SERVICE BULLETIN

ENGINE FUEL AND CONTROL — DATA ENTRY PLUG (DEP) — REPLACEMENT
OR MODIFICATION OF, TO PROVIDE SCN22/AB SOFTWARE AND REDUCED
GROUND IDLE (RGI) CAPABILITY

V2500 Series 73-0237

V2500-ENG-73-0237

LOCATION OF DEP ASSEMBLY
73-22-35
FIGURE 1

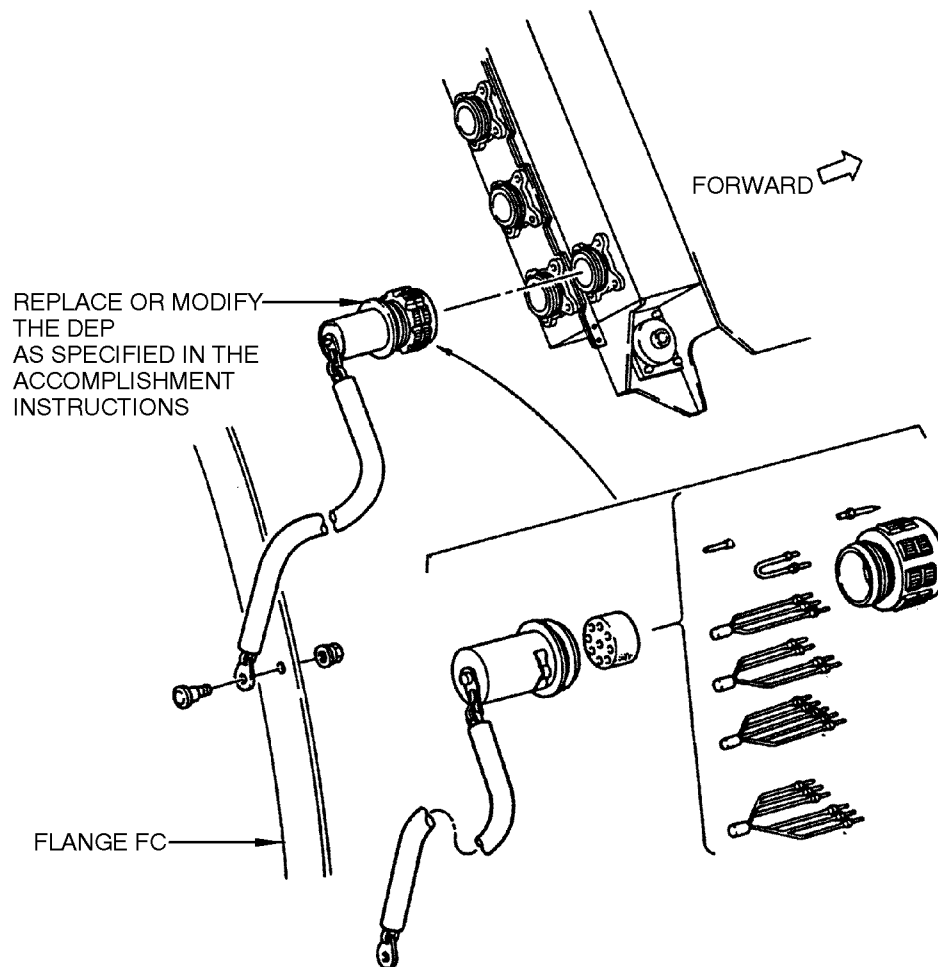
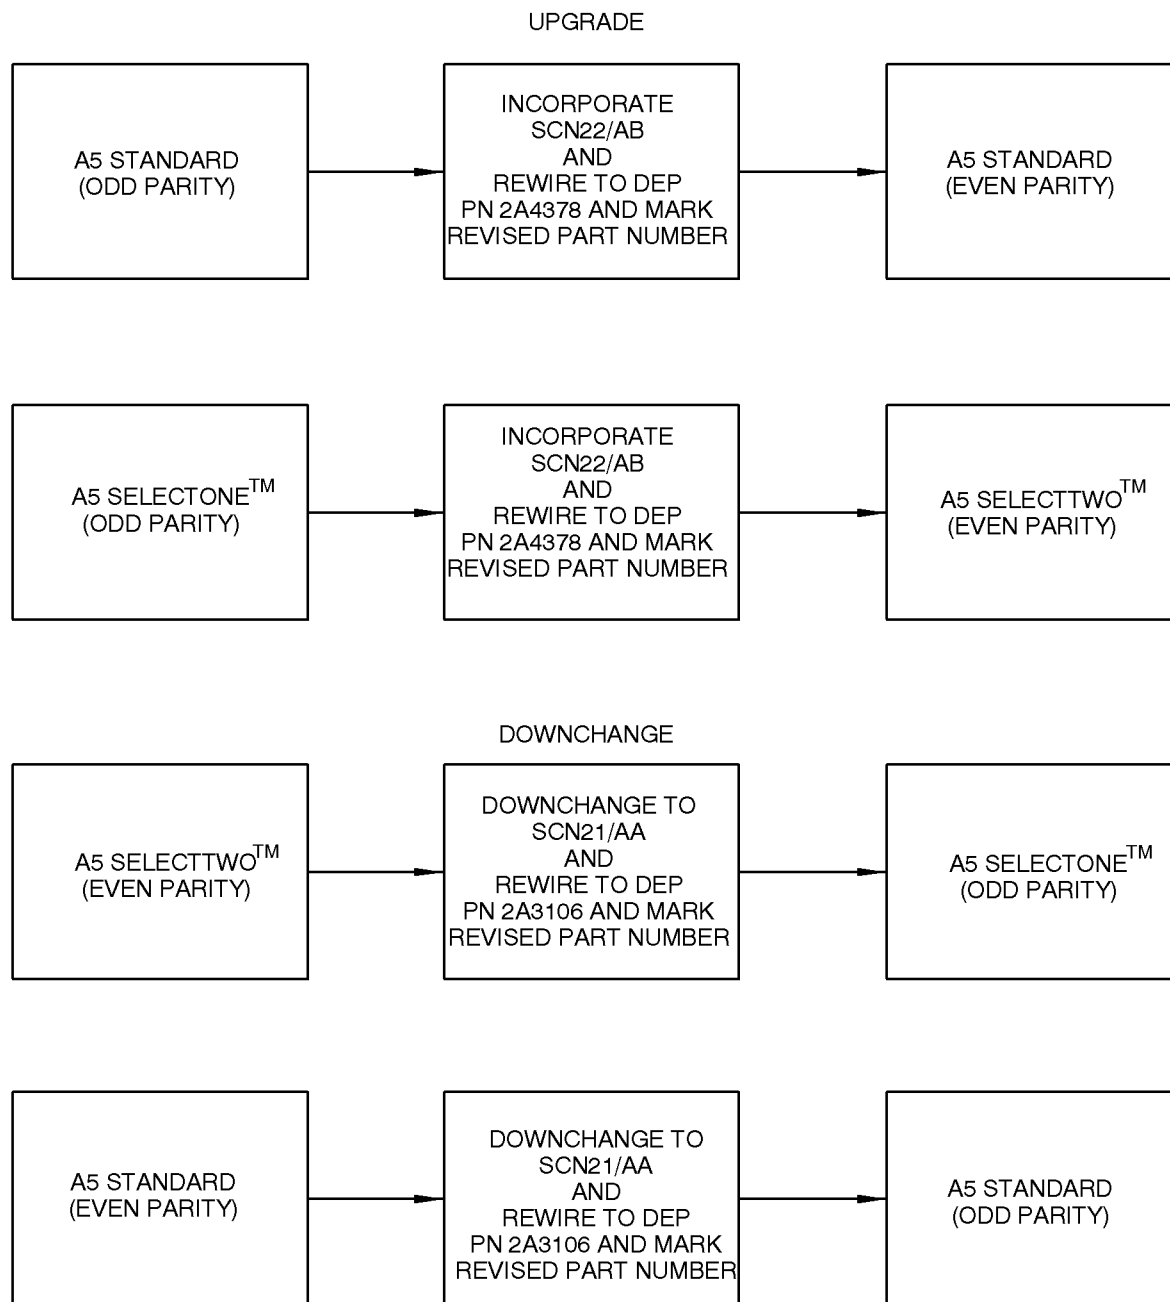
1. Replace the Data Entry Plug (DEP) Assembly, PN 2A3106 with PN 2A4378 or do a modification of the DEP Assembly, PN 2A3106 as follows. See Figure 1.
 - A. Rewire the DEP to the specified engine variants as listed in Appendix, Table 1. Refer to the latest Reference 4, Service Bulletin No. V2500-ENG-72-0285 for instructions.
 - B. Appendix, Table 1 lists the engine variant numbers that are incorporated into the new DEP.

1. Replace the DEP Assembly, PN 2A3106 with PN 2A4378 or do a modification of the DEP Assembly, PN 2A3106 as follows. See Figure 1.
 - A. Rewire the DEP to the specified engine variants as listed in Appendix, Table 1. Refer to the latest Reference 4, Service Bulletin No. V2500-ENG-72-0285 for instructions.

UPGRADE AND DOWNGRAPH INSTRUCTIONS
FIGURE 2

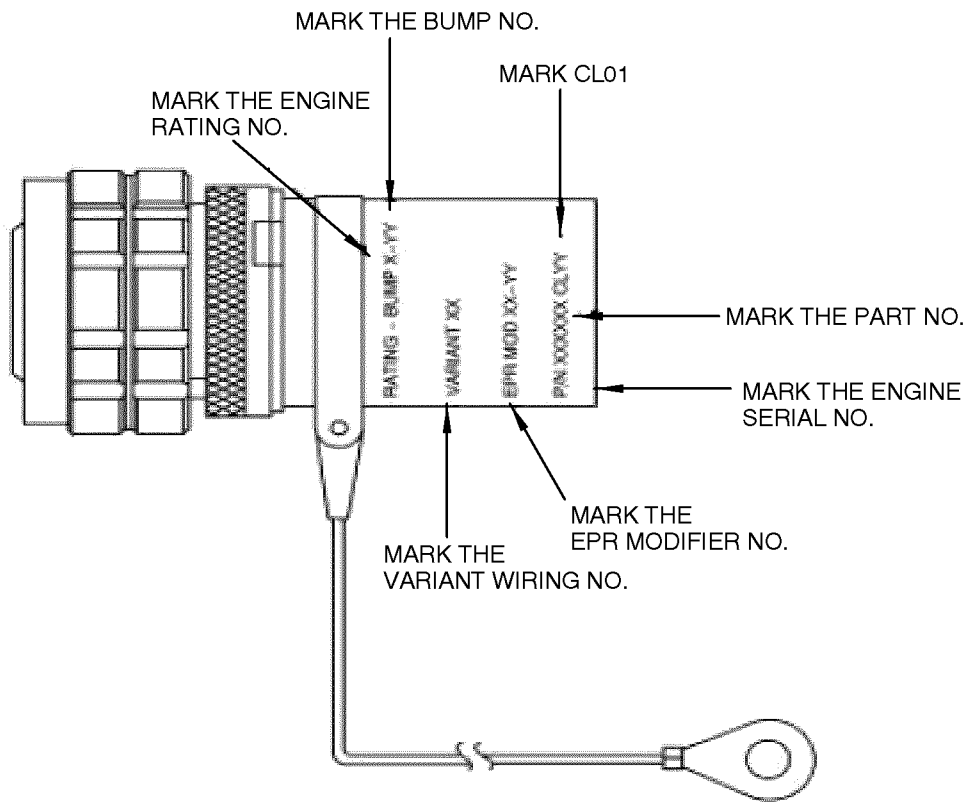
NOTE: Even though DEP, PN 2A4378 is introduced primarily for V2500-A5 SelectTwo™ Configurations, it can be used for both V2500-A5 Standard and SelectOne™ Configurations. See Figure 2 for explanation.

NOTE: Even though DEP, PN 2A4378 is introduced primarily for V2500-A5 SelectTwo™ Configurations, it can be used for both V2500-A5 Standard and SelectOne™ Configurations. See Figure 2 for explanation.
